Bulletin

MODEL: BENTLEY MARK VI

MODIFICATION.

- a) Rear Axle Retaining Bolts.
- b) Rear Brakes - Equal wear Linkage.

FIG. 1.

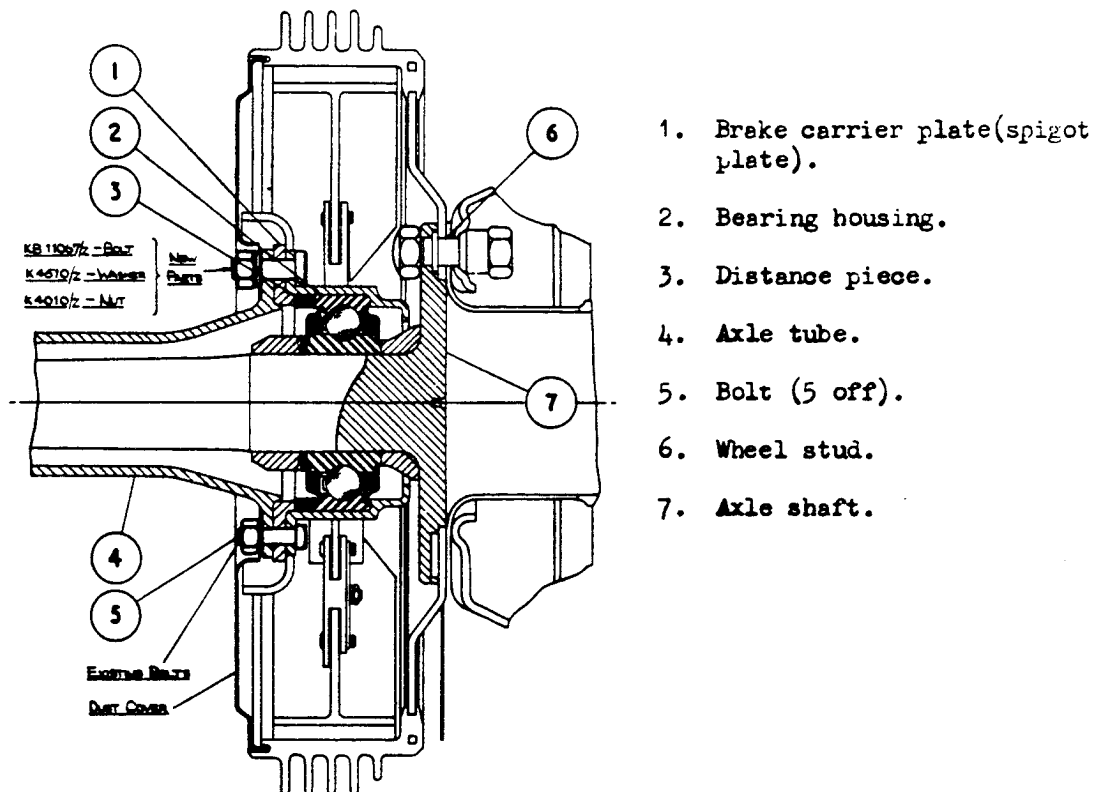
It has been decided to fit 3/8" diameter bolts as shown on Fig.1, in place of the existing 5/16" diameter bolts (5) which retain the rear axle shaft bearing housing (2) and the brake carrier plate (1) to the axle tube. It has also been decided that opportunity should be taken to reverse the equal wear brake linkage of the rear brakes and fit the stiffened linkage which consists of a new push rod and jaw.

- (iii) Unscrew the five 5/16" B.S.F. nuts from the bolts (5 Fig.1) lying inside the recess in the dust cover at the rear of the brake carrier plate and gently draw out all the bolts which retain the axle shaft bearing housing (2) and the brake carrier plate (1) to the axle tube (4).

FIG. 2.

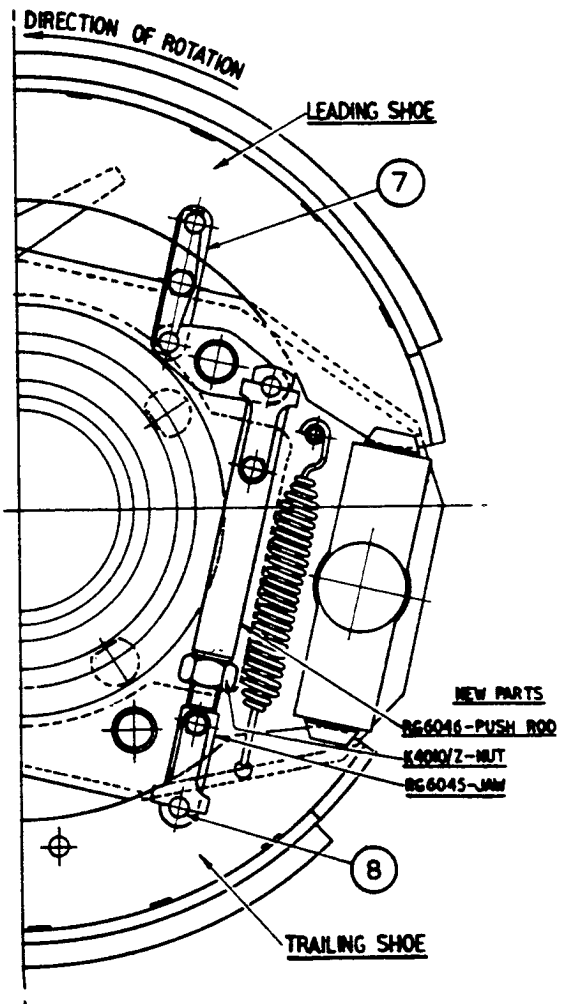
Although some cars will already have the unstiffened linkage reversed and others will have the stiffened linkage, it is desired that all cars should be brought to the full modified standard as soon as possible. The decision to reverse the brake linkage and fit the stiffened type is in order to eliminate the possibility of the rear brakes developing a jamming action (spragging), due to the trailing shoes pivoting about the inter shoes equal wear linkage instead of about the adjuster end of the shoe. A modification has been introduced, moving the point of attachment of the linkage to the trailing shoe nearer the adjuster. This is done by simply reversing the linkage and the central pivot of the linkage, so that the shorter of the two links is now attached to the leading shoe instead of to the trailing shoe as was previously the case. (See Fig.2).

- (ii) Unscrew the two setscrews retaining the locking plates (1 & 6 Fig.2) on the inter shoe linkage nearest each shoe and pull out the pins holding the links to the shoes and withdraw the complete linkage away from its pivot (5). Do not disturb the setting of the push rod by turning the jaw relative to the rod. It is advisable before removing the linkage, to check the locknut (2) on the push rod for tightness.
- (iii) With a 7/16" (B.S.F.) cranked ring spanner, remove the locknut, the Grover and plain washer from the back of the pivot (5) and transfer the pivot from its position just above the lower or trailing shoe to the existing hole in a similar position just below the upper or leading shoe. (See "Modified" Drawing Fig.2).

FIG. 1.

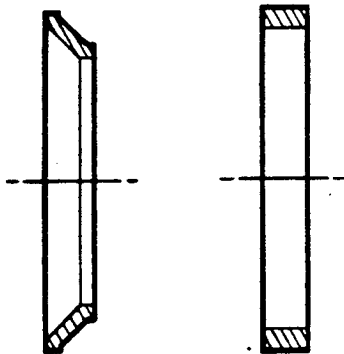
In addition to carrying out the modifications as detailed in Bentley Service Bulletin No: BB-73 (Section L), it has also been decided to reduce the nip on the outer race of the ball bearing on the axle shaft to zero by reducing the width of the distance (adjusting) piece, (3 Fig.1 of Bulletin BB-73) from 0.002" to 0.003" (0.050 m/m to 0.076 m/m) whatever the width of the distance piece may be found to be.

Fig. 1 (below) is a section through the distance piece fitted to the ball bearing assembly of the axle shafts for chassis series 'AK', 'AJ', 'BH' and 'BG' and Fig. 2 is a cross section through the distance piece fitted to the ball bearing assembly of the axle shafts for series 'CF', 'CD' and onwards.

- (i) After the removal of an axle shaft as described in Bulletin No: BB-73, remove the distance piece from the ball bearing housing which is a free fit.
- (ii) Carefully measure the width of the distance piece and reduce the width by machining 0.002" to 0.003". The distance piece is made of mild steel. In the unlikely event of machining facilities not being available, then it will have to be carefully reduced by hand, keeping the faces parallel.
- (iii) Repeat for the opposite side.

FIG. 1. SECTION - REAR AXLE SHAFT ASSEMBLY.

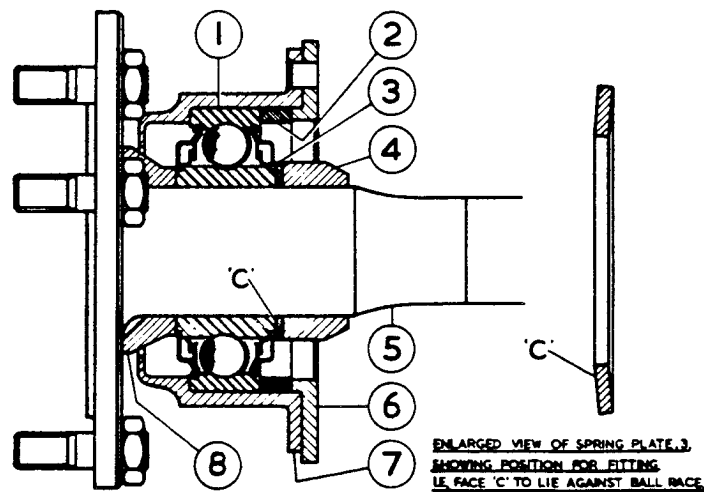
Hitherto when it has been necessary to renew an axle shaft ball bearing, it has been the practice to replace the complete axle shaft assembly and return the original assembly to the London Service Station for reconditioning. This is because the bearing retaining collar was shrunk on the axle shaft and required elaborate tackle. It has now been decided to press the collar on cold, and providing Retailers have the facilities of a suitable press, they should be able to remove and replace a bearing as described in this Service Bulletin. The load required to press the collar into position is from 6 to 10 tons.

- (i) With a micrometer, measure the width of the outer race of the old and new bearing. The variation in outer race width should not exceed .002" = .05 m/m (maker's figure). If the new bearing is wider, a similar amount should be ground off the adjusting piece (2 Fig.1), but if it is narrower or of identical width, the adjusting piece can be refitted without alteration. A .002" end float of the adjusting piece, between the outer race of the bearing and the spigot plate, could arise from this procedure which is permissible.

- (iii) Next place the distance piece (8) on to the axle shaft followed by the housing complete with bearing and press the bearing fully home. Fit the spring plate (3), making sure it is positioned the correct way round (See Fig.1).

FIG. 2. CLOCKING TOP FACE OF SPIGOT PLATE.

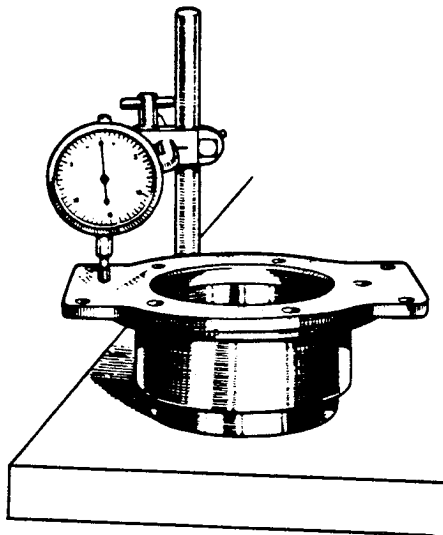
- b) Place the sub-assembly on a surface plate with the spigot plate uppermost and clock the top face of the spigot plate (See Fig.2). Fit a new adjusting piece (RG-3181), bolt up as before, and again clock the face of the spigot plate. An amount equal to the difference in clock readings should then be ground off the adjusting piece. The aim is to obtain zero nip on the bearing, but a nip NOT EXCEEDING .002" (.05 m/m) is permissible.
